Browns Ferry Nuclear Plant, Units 1, 2, and 3
Renewed Facility Operating License Nos. DPR-33, DPR-52, and DPR-68
NRC Docket Nos. 50-259, 50-260, and 50-296

Subject: Proposed Technical Specifications (TS) Change TS-505 - Request for License Amendments - Extended Power Uprate (EPU) - Supplement 16, Responses to Requests for Additional Information

Responses to RAIs for Browns Ferry Nuclear Plant EPU Submittal - Nuclear Performance and Code Review Branch

ANP-3487NP
Revision 0

Figure 3 Lattice Reactivity Comparison at Same Enrichment

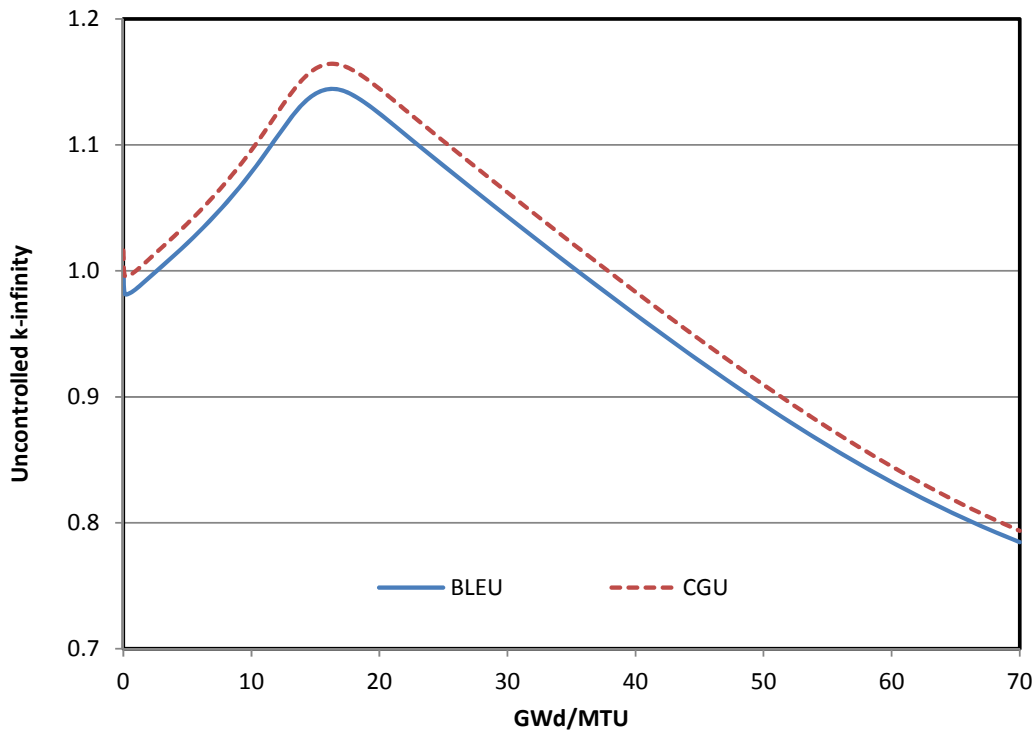
Is the 30 percent BLEU fuel that will be introduced into Unit 3 for Cycle 19 higher than the BLEU percent for the ATRIUM 10XM fuel transition for the Unit 3 in 2013 LAR? If this percentage is higher than the percentage of BLEU fuel in 2013 fuel transition, what is the impact on the buildup of various uranium isotopes during the depletion of the fuel? Also discuss the impact of the various uranium isotopes on reactivity.

This reduction in reactivity is illustrated in Figure 3 for lattices with the same enrichment and Gadolinia distributions (i.e., the only difference is the presence of U^{234} and U^{236} in the BLEU lattice).

The figures provided in this response are the same as those previously provided in Reference 22. The previous response remains applicable to the use of BLEU in BFN at EPU conditions.
